Herts Highways – Roger Flowerday Response to SRAC Minute 33 (9) - 30th September 2010 Meeting

That the Community Development Officer request that Hertfordshire Highways provide sight of the legislation which would prevent warning signs being placed in advance of the pedestrian crossing at Whitehorse Lane, Great Ashby". from Roger Flowerday – Herts Highways.

547.8 Zebra crossing or signal-controlled crossing on road hump ahead

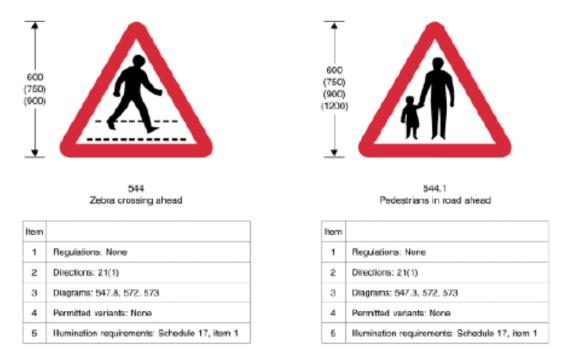
For example one might consider using either of the two signs below, however diagram 544 can only be used at a Zebra crossing and 544.1 which denotes 'pedestrians in road ahead' can only be used where pedestrians frequently use a road without a proper footways, clearly this is not the case on Whitehorse Lane.

Some might also suggest that sign 547.8 (detailed below) be utilised, however this is merely a sub plate which must be used in conjunction with sign 544 above.

Any sign placed on the highway must conform to The Traffic Signs Regulations and General Directions 2002 (TSRGD). Specifically pedestrian crossings are covered by the Traffic Signs Manual Chapter 4 - Item 9. Within this item it details the signs that can be permitted at pedestrian crossings. Unfortunately, as I explained previously none of these signs can be placed on Whitehorse Lane as they do not meet the criteria for installation. This is primarily because there is no permitted sign in the TRSGD that enables one to provide advanced warning of an uncontrolled crossing.
